Access Compliance Report

Public Rights-of-Way

Intersection ID: 47569	Main Street: ROWE_CT	Cross Street: HERMSLEY_RD	Location:	N
ADA ID: A67ACCAB7649	Ramp Type: BlendTrans1	Initial Pass/Fail: Pass	Overall Compliance: No	Severity Score: 5

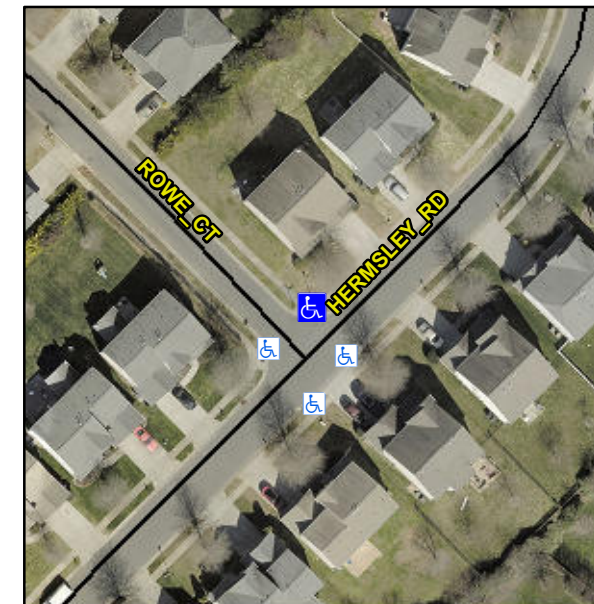
**R304.2.1, R304.2.2-Perp, R304.3.2-
Para, R304.5.4**

**Remove & Replace Landing.
Remove & Replace Gutter.**
